Appraisal of Design Proposals
New Barnet Victoria Quarter
for the Save New Barnet Group

August 2021

The gridded site layout in the current proposal (above)

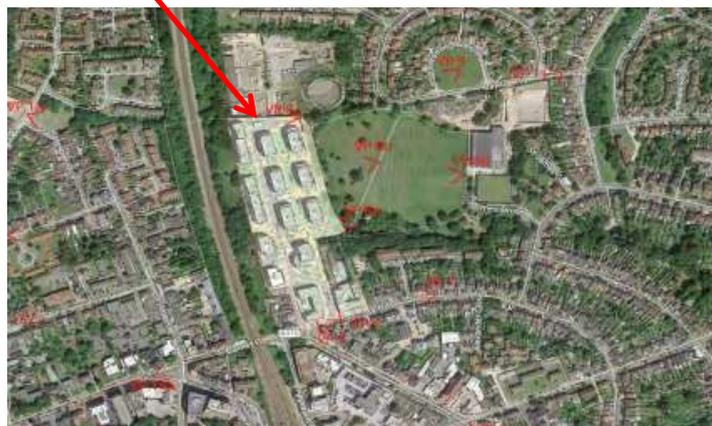
The current proposal does not relate to the pattern of streets in the neighbouring area

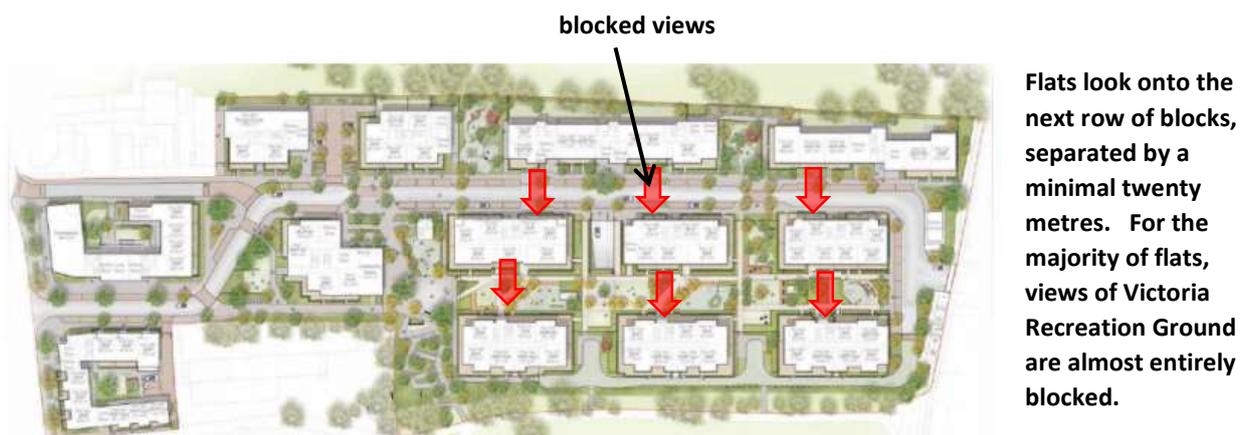
Aerial views highlight the monolithic uniformity of the blocks. Because no site boundary is indicated in this view, a misleading impression is given of the amount of amenity space provided

The current design (left)

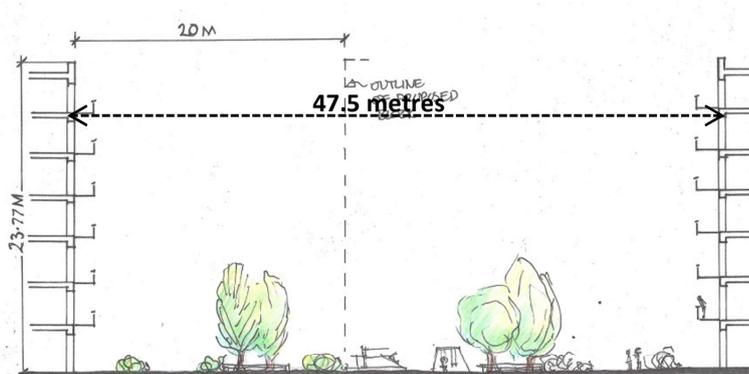
The only section through the communal gardens (left) shows Block B2 (six storeys). In fact, the majority of the garden is dominated by seven storey apartment blocks (shown as a dotted line) on either side at a distance of only 20 metres. The separation distance between balconies is 17 metres.

Elevation of apartment blocks from Victoria Recreation Ground: Blocks are not stepped down towards the park so there is no mediation in scale. The change in brick colour is deceptive; it does not indicate a set back

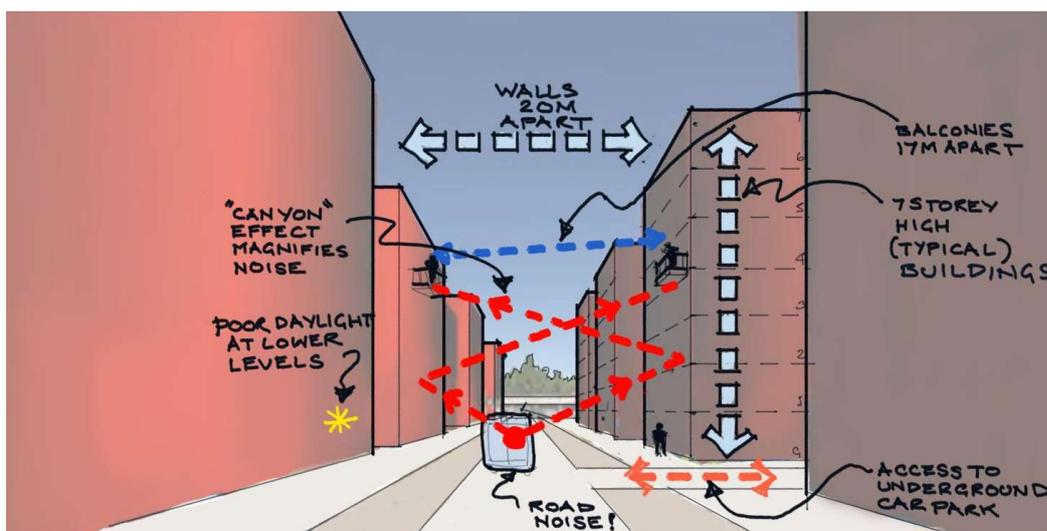
The verified view in the DAS, when shaded in, gives a more representative impression of the effect the new development will have on the park.

Many of the verified views in the DAS show only a dotted line, underplaying the impact of the development on surrounding spaces. This impact will have a particularly detrimental effect where apartment blocks sit on the boundary with Victoria Recreation Ground.

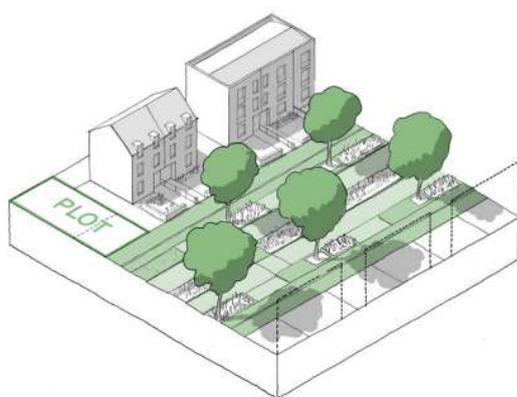
Following this guidance, an eaves height of just ten metres would be appropriate on Spine Road. Maintaining building heights of 23.77 metres would require a road width of 47.5 metres

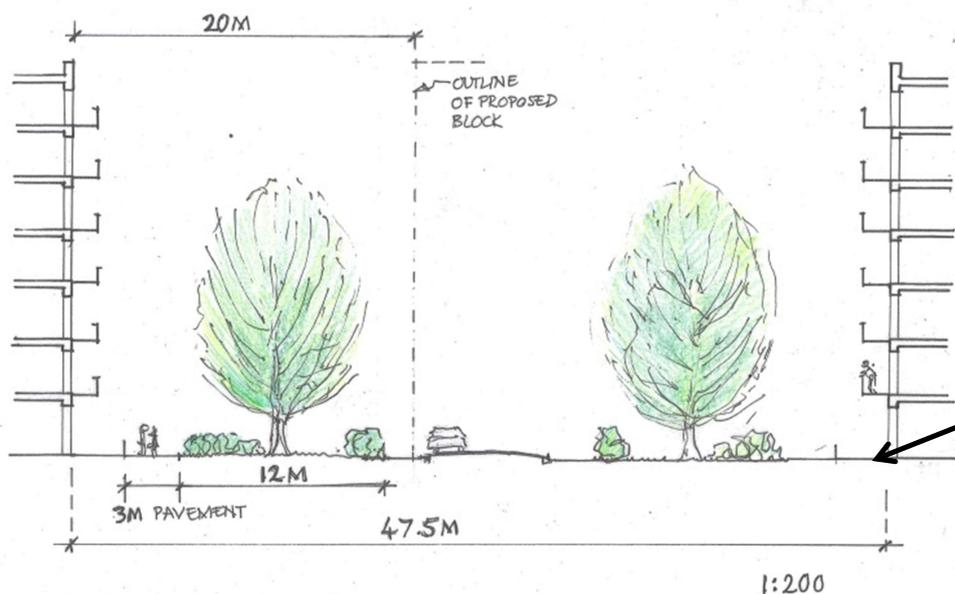
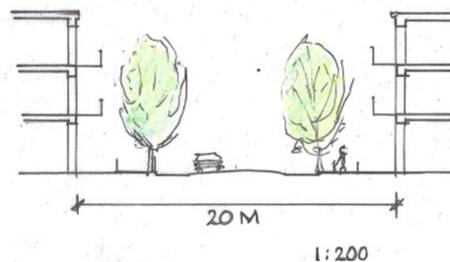
Below left: a distance of 20 metres between blocks results in narrow pavement widths and allows for only small trees to be planted (which do not act as a wind break for prevailing wind). Noise is trapped between buildings creating a noise canyon. The distance between balconies is only 17 metres

Below right: according to the National Model Design Code, to retain comfortable proportions, three storey buildings would be appropriate for a road width of 20 metres in a suburban area

Wind microclimate diagram (above)

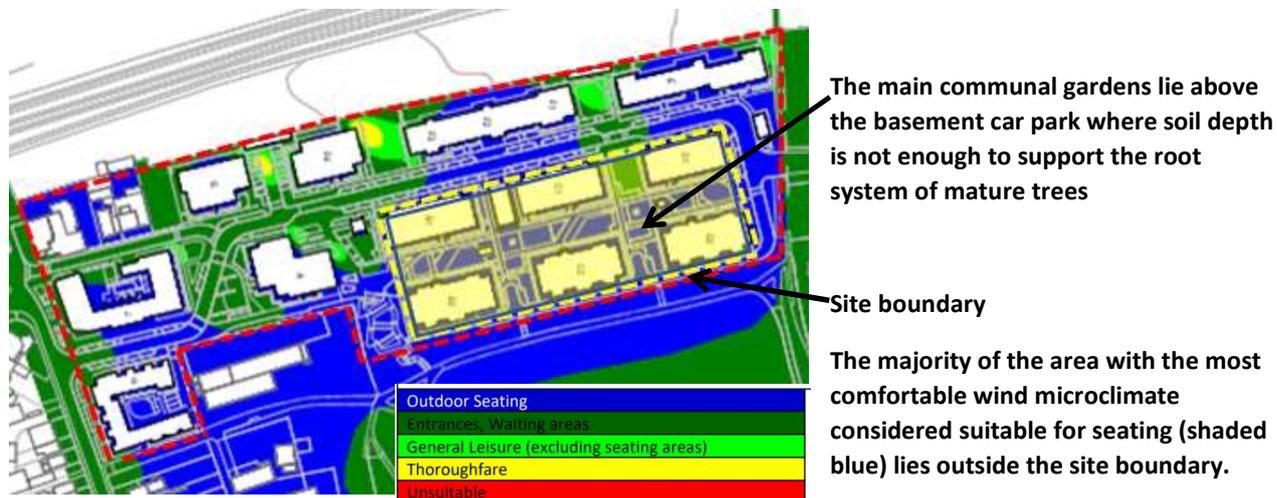
Taller buildings can create a windy microclimate. Looking at the analysis (below), it appears at first glance that levels of comfort are good but in fact the majority of the area regarded suitable for outdoor seating (shaded blue) lies outside the site. The orientation of the blocks also means that *'There remains potential for channeling of prevailing south-westerly winds along the western elevations and through the gaps between the blocks, into the site'*(Wind Microclimate Report)

The predicted microclimate depends on mature planting, including trees; the report states that, *'The current assessment assumes that the trees will be planted semi-mature and be of a deciduous species with substantial canopies ... such that the landscaping proposals are expected to be beneficial in helping alleviate wind flows across the site.'* However, the main communal gardens lie above the basement car park –and soil depth here of only 450mm is not enough to support the root system of larger, mature trees which will therefore need to be planted in large, raised beds. Moreover, The DAS states that, *'Within the Courtyards, the approach is to use smaller, multi-stem trees.'* Illustrations of the garden area (below) suggest that these may not be as effective in terms of providing a wind break as the trees with *'substantial canopies'* needed to *'alleviate wind flows'*.

Many of the areas shown as suitable for outdoor seating do not have the mature trees with *'substantial canopies'* which are required in order to achieve these comfort levels. Illustrations of the communal gardens show *'smaller, multi stem trees'* and, in Spine Road, smaller trees have been specified which are *'well suited along narrow street avenues'*.

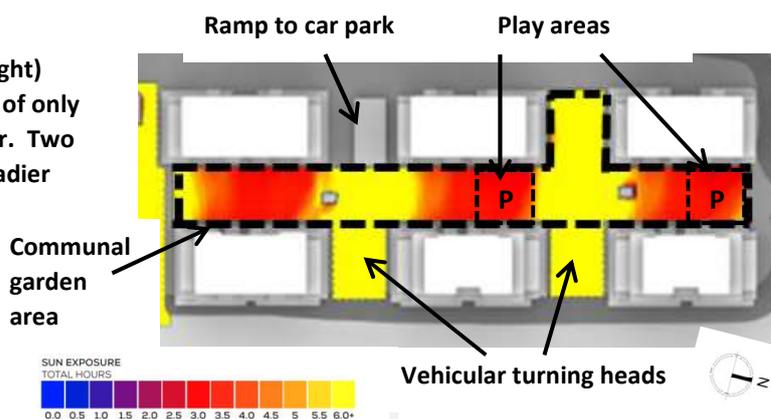
The overshadowing diagram for 21st June (right) shows that half the garden gets a maximum of only three hours sunlight in the height of summer. Two children’s playgrounds are located in the shadier areas making them less pleasant to use.

Areas between the ends of blocks are sunnier but are utilized as the ramp to the car park and turning areas for the service road

Block G

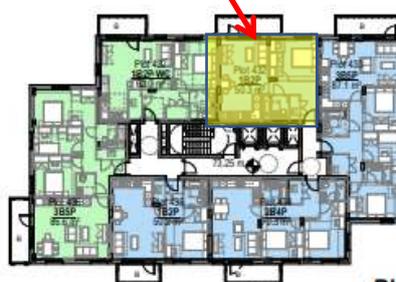
The air source heat pump at ground level is likely to impact negatively on flats in Block G: standard flat plans show living rooms with balconies directly over the plant room. Facing west, over the railway, environmental conditions in these flats, including private amenity space will be very poor.

West facing habitable rooms overlook the railway so are doubly compromised by both heat and noise especially at third floor level and above. Some flats (shaded yellow) are single aspect.

15. Appendix 5: Noise Contours across the Proposed Development Site

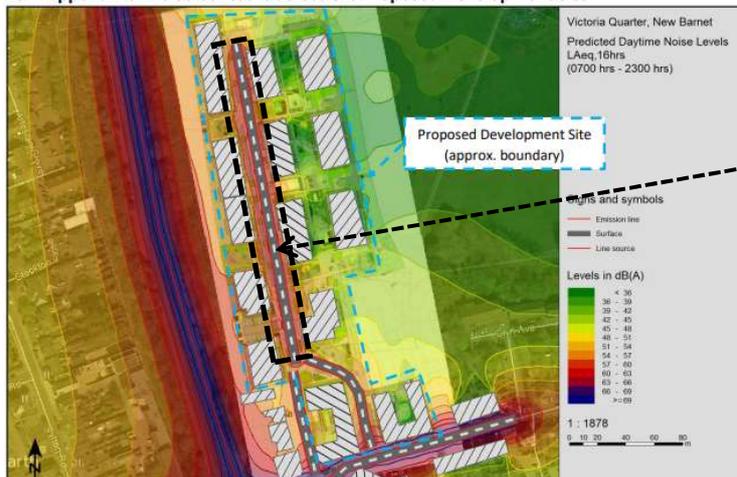
The acoustic diagram (below) shows a concentration of noise along Spine Road. This is typical of the acoustic effect of an urban street, with tall buildings to either side effectively trapping noise, creating a ‘noise canyon’. This noise problem, generated by the design, was also a feature of the refused application; retaining the same overall layout and height strategy (six out of nine blocks on Spine Road are seven storeys or more) means that there have been no design modifications which address this problem. GLA pre application advice given in relation to single aspect flats (See Appendix 1) listed noise as a reason to avoid this type of layout yet there are 61 single aspect flats (11.2%) on Spine Road.

Noise levels of between 57 and 60 dB are predicted on Spine Road, effectively creating a noise canyon.

Top-heavy appearance

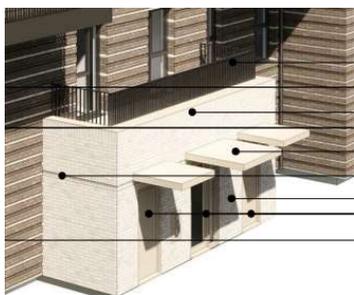
Top floors, which could be treated as an attic storey look heavy with an additional band of brickwork above the windows to conceal lift machinery. An alternative approach, used in the consented scheme, would be to use a more lightweight material -metal cladding perhaps – and set back the upper floors, referencing an ‘attic’ storey.

Utilitarian balconies: the majority of balconies are standard vertical rail type, utilitarian in appearance (reminiscent of fire escape railings) and providing little privacy or shelter from noise.

Plant on top of Block G is hidden behind a band of metal louvres. These are made to look solid in this drawing which is misleading; they will look functional and utilitarian in reality, more in keeping with industrial premises than with housing.
